ACCESSION NBR: 8101130093 DOC. DATE: 81/01/09 NOTARIZED: NO DOCKET #
 FACIL: 50-361 San Onofre Nuclear Station, Unit 2, Southern Californ 05000361
 50-362 San Onofre Nuclear Station, Unit 3, Southern Californ 05000362
 AUTH. NAME AUTHOR AFFILIATION
 BASKIN, K.P. Southern California Edison Co.
 RECIP. NAME RECIPIENT AFFILIATION
 MIRAGLIA, F. Licensing Branch 3

SUBJECT: Forwards responses to numerous open items & questions identified in NRC 801107 ltr & meetings w/NRC during wk of 801215. Direct distribution will be made as part of Amend 23 distribution per svc list provided in util 801029 ltr.

Subject: Docket Nos. 50-361 and 50-362
San Onofre Nuclear Generating Station
Units 2 and 3

Enclosed are sixty-three (63) copies of responses to numerous NRC Open Items and questions identified in the NRC letter dated November 7, 1980, and meetings with the NRC staff during the week of December 15, 1980. Enclosure 1 is a list of the responses which are included in Enclosure 2.

SAN ONOFRE NUCLEAR GENERATING STATION Units 2 & 3
MAIN STEAM SYSTEM: LINES 1301-017-6, 1301-017-4, 1301-577-6, AND 1301-577-4 (SAFETY EQUIPMENT BUILDING) LOCATION OF HIGHEST STRESS NODE POINTS, POSTULATED BREAKPOINTS, AND RESTRAINTS
Figure 3.6A-34

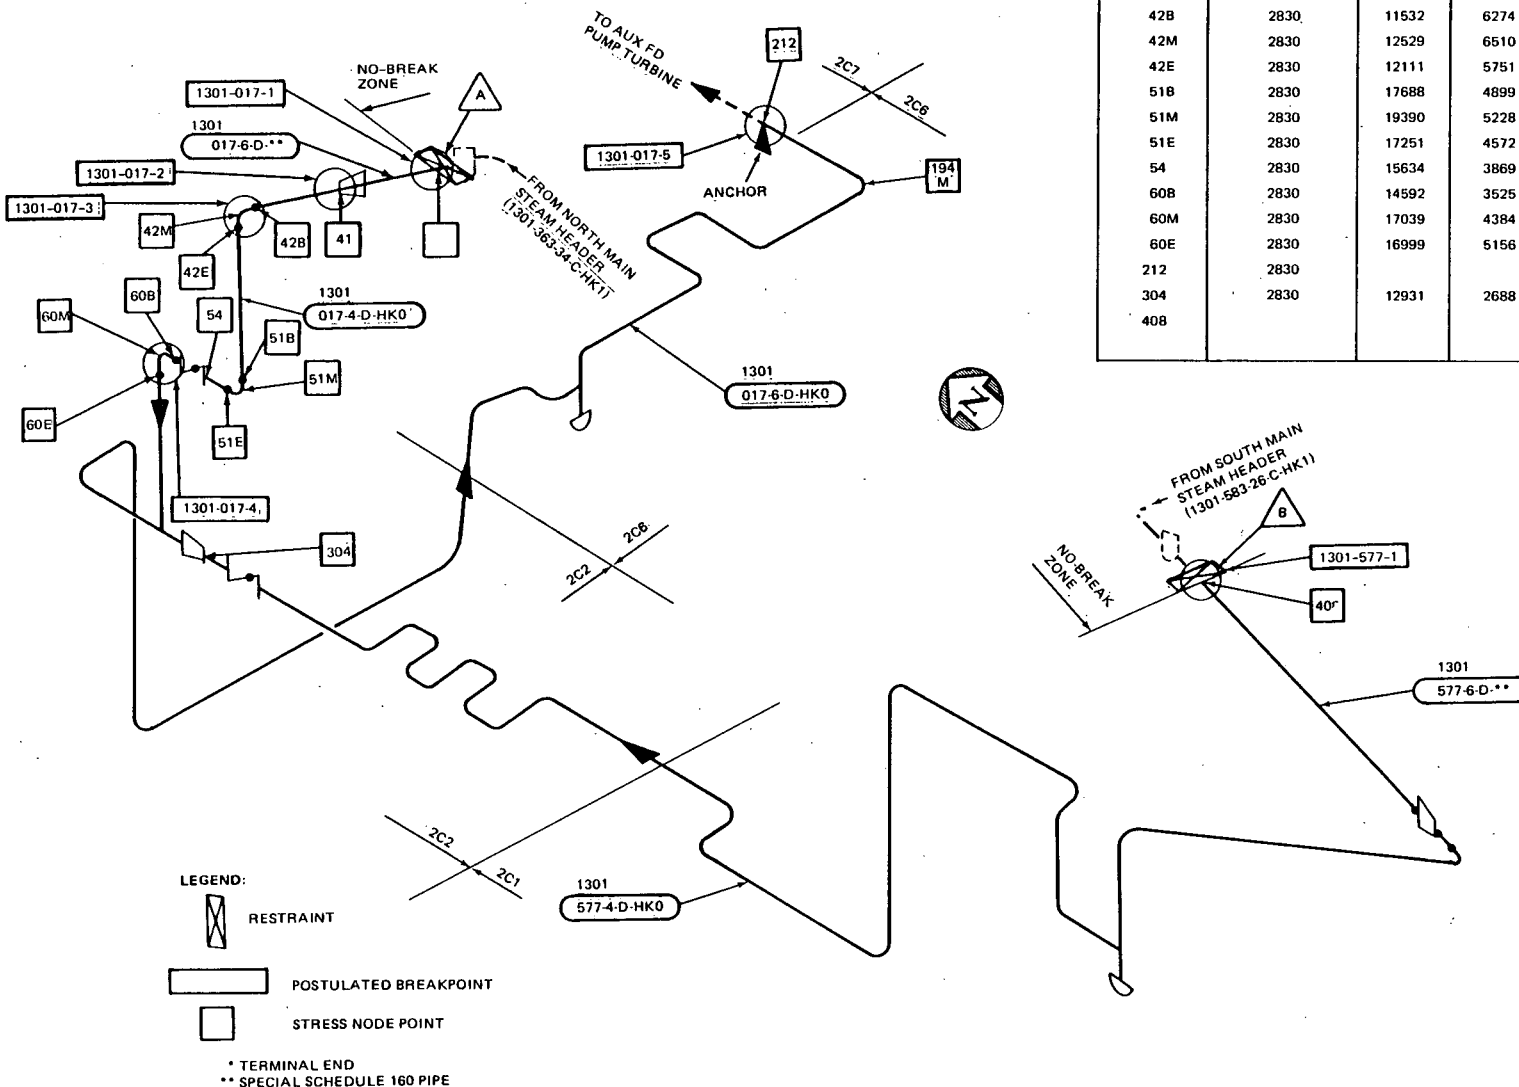
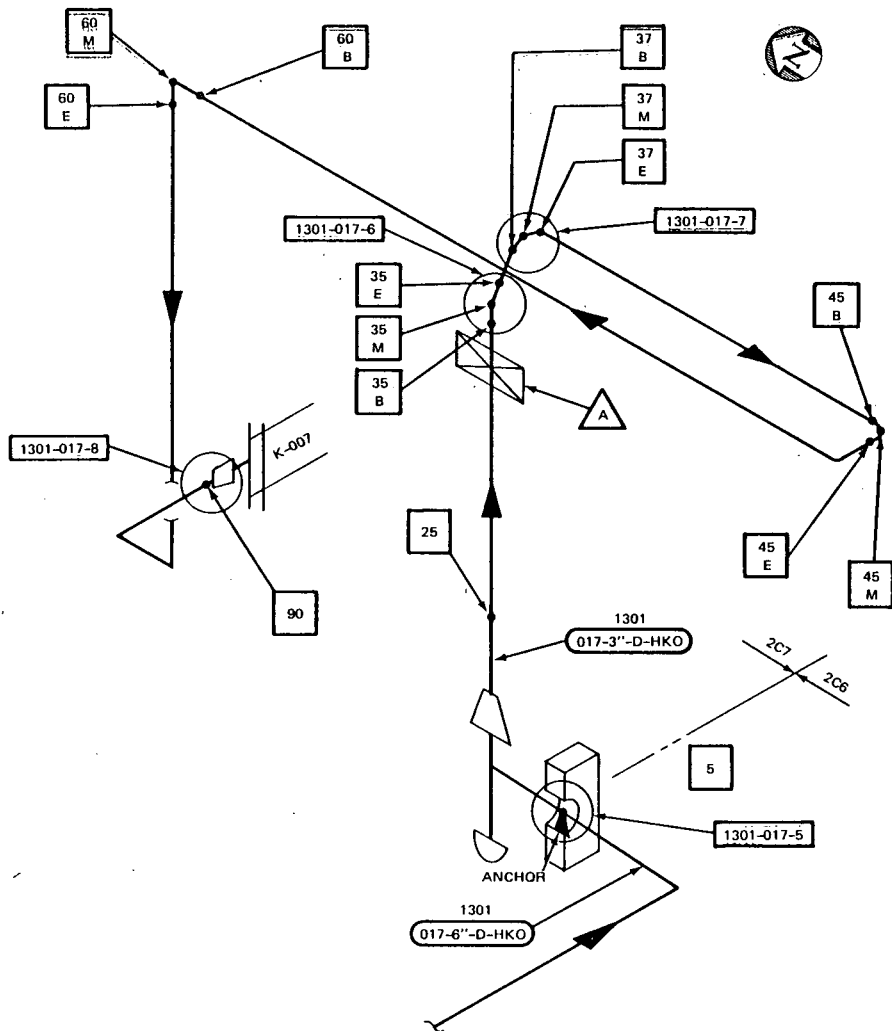
An isometric of these lines, indicating the location of the highest stress node points, postulated breakpoints, and restraints, is provided in figure 3.6A-34. The systems and equipment necessary to mitigate the consequences of a break in these lines are described in paragraph 3.6.1.2.B Lines 1301-004-6, 1301-004-4, 1301-578-6, 1301-578-4, and a portion of the heavy schedule 160 lines 1301-577-6 and 1301-017-6 are designed in accordance with the criteria in paragraph 3.6.2.1.2.2.D. Therefore, pipe breaks are not postulated in the regions between the relief valve headers and the restraint downstream of the isolation valves.

In accordance with paragraph 3.6.2.1.2.2, a review of the piping layout and plant arrangement was made to verify that the effects of the breakpoints 1301-557-1, 1301-017-1, 1301-017-2, 1301-017-3, 1301-017-4, and 1301-017-5 are isolated, physically remote, or restrained by plant design features from essential systems or components. In the area of the SEB, these lines are separated from essential systems by concrete walls and ceilings with a minimum thickness of 2 feet. Analysis has shown that the unrestricted motion of any of these lines is either physically remote from essential systems or does not have enough energy to damage a 2-foot-thick concrete barrier. Therefore, the only pipe whip restraints required are the restraints downstream of the isolation valves.

Figure 3.6A-39A

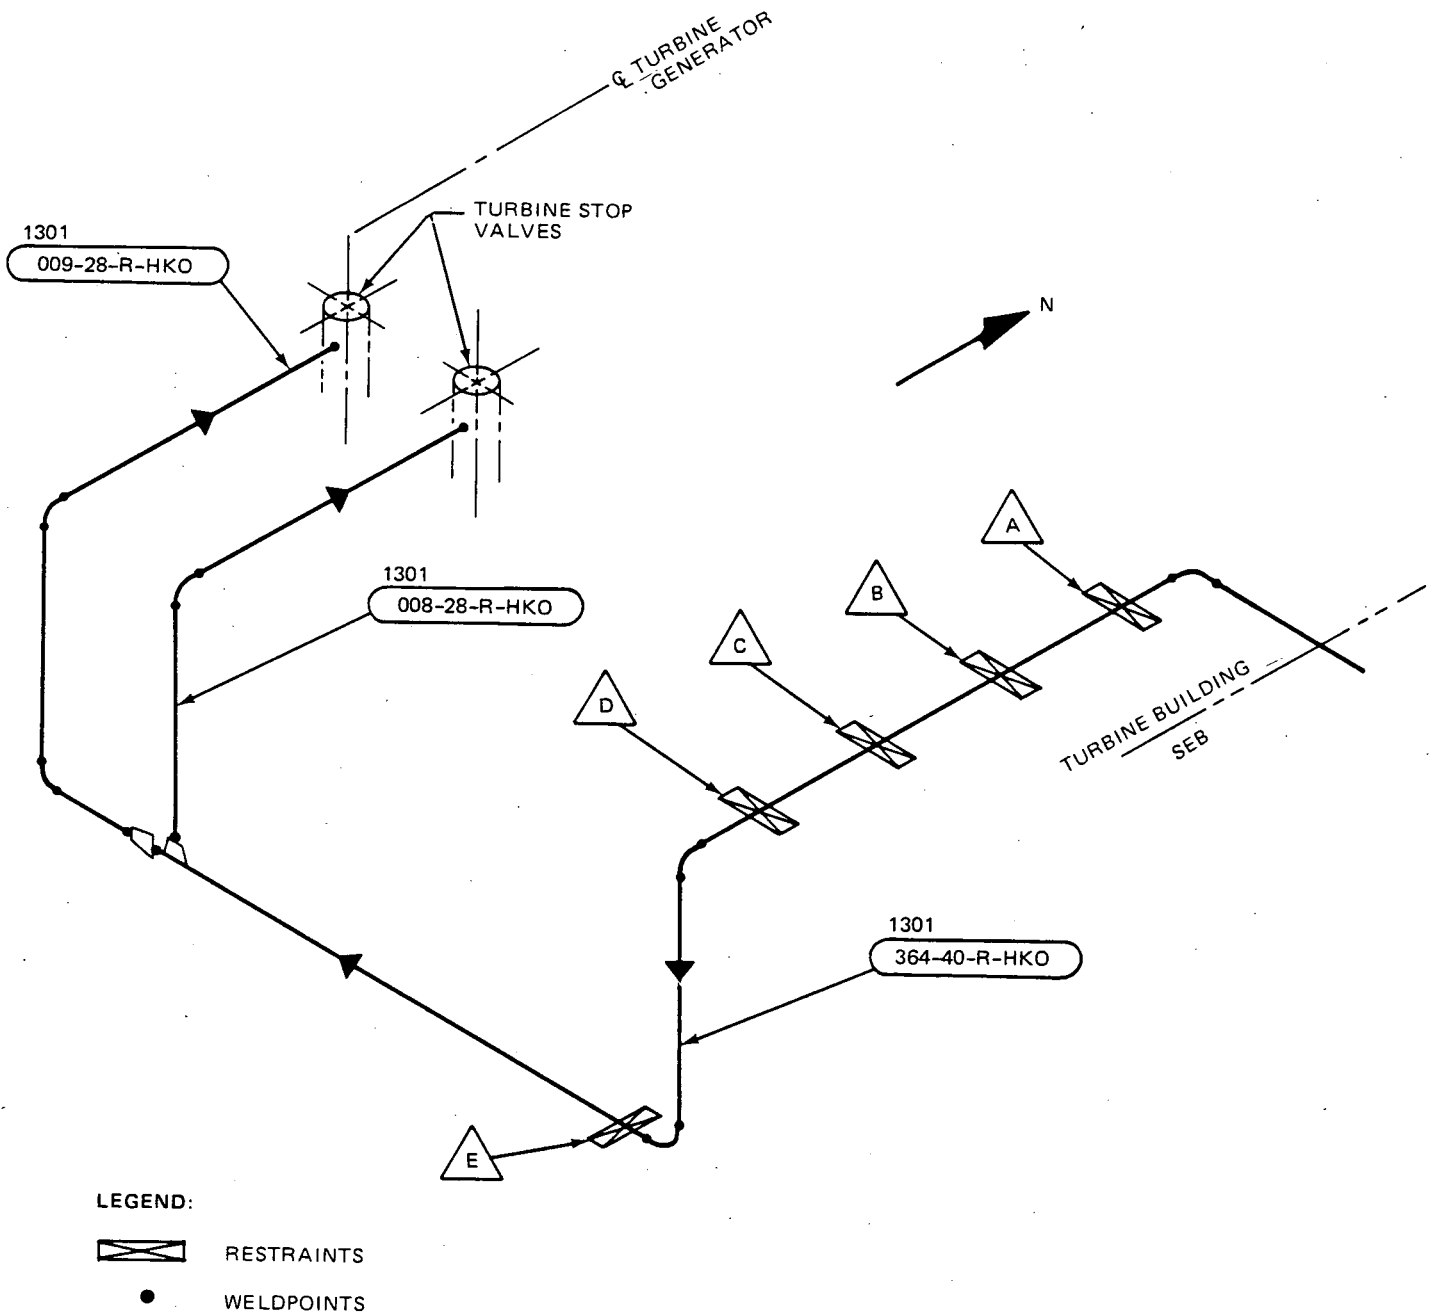
23 | An isometric drawing of these lines indicating the location of the highest stress node points, postulated breakpoints, and restraint location is provided in figure 3.6A-39A. The systems and equipment necessary to mitigate the consequences of a steam line break are described in paragraph 3.6.1.2.B. Breakpoints were postulated at the terminal ends and at two intermediate locations for the piping system in accordance with the criteria outlined in paragraph 3.6.2.1. A single circumferential break is postulated to occur at any one of the breakpoints. Longitudinal breaks are not postulated at the terminal ends because of the pipe's seamless construction and intermediate longitudinal breaks are not postulated since the criterion for a minimum number of breaks is satisfied.

In accordance with paragraph 3.6.2.1.2.2, a review of the piping layout and plant arrangement was made to verify that the effects of breakpoints 1301-017-5 and 1301-017-8 are isolated, physically remote, or restrained by plant design features from essential systems or components. A pipe whip restraint is provided to prevent excess pipe motion from the effects of breakpoints 1301-017-6 and 1301-017-7. The pipe whip restraint is designed to prevent plastic hinge formation and thereby preclude adverse pipe whip effects on essential systems or components.

Although only two intermediate breakpoints were selected and analyzed, a review of the piping layout was made to verify that the selected intermediate breakpoints are located in the most adverse locations. The effects of any other potential breakpoints are isolated, physically remote, or restrained by plant design features from essential systems or components.

FIGURE 121.43-1

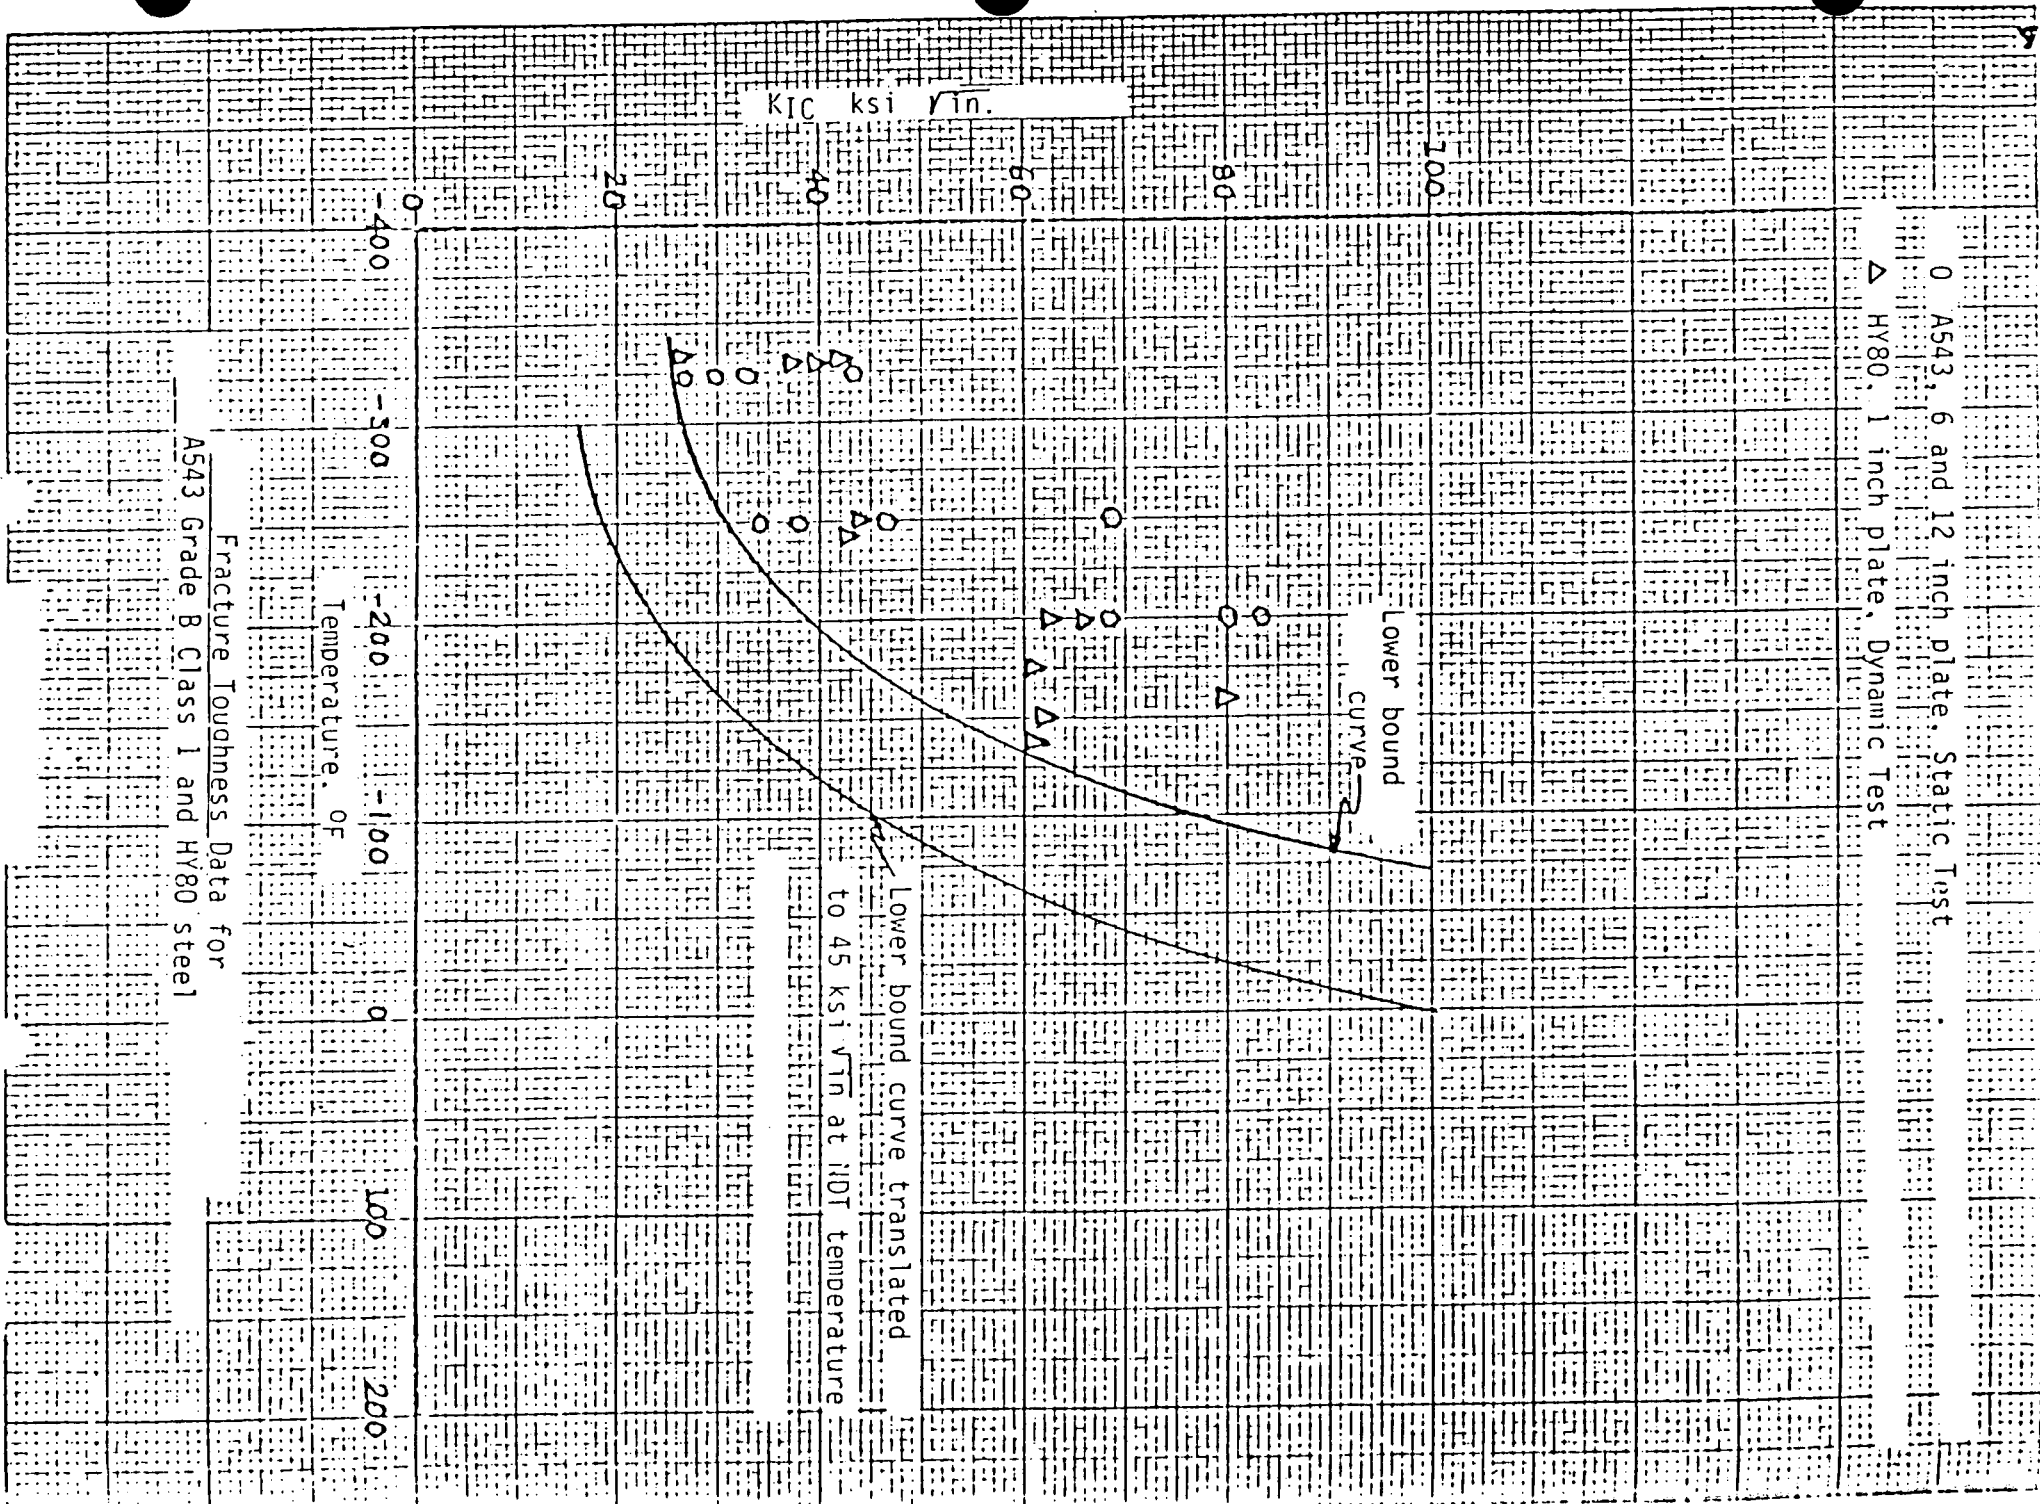
The lower bound fracture toughness curve (figure 121.43-1) is based on static fracture toughness data¹ for A-543 Grade B Class 1 material and dynamic fracture toughness data² for HY80, a material very similar to A-543. Dynamic fracture toughness data for A-543 is not available in the literature. The reported mechanical and chemical composition of A-543 and HY80 are tabulated in table 121.43-1.

In accordance with paragraph C.1.C(3) of Regulatory Guide 1.14, Rev. 0, the lower bound curve shown in figure 121.43-1 has been translated along the temperature coordinate until a K_{IC} value of 45 ksi $\sqrt{\text{in}}$ is indicated at an NDT temperature of -100F. The -100F is the highest NDT temperature obtained from drop weight tests for actual flywheels as reported in response to NRC Question 121.26. The translated curve shows that 100 ksi $\sqrt{\text{in}}$ occurs at approximately 0F.
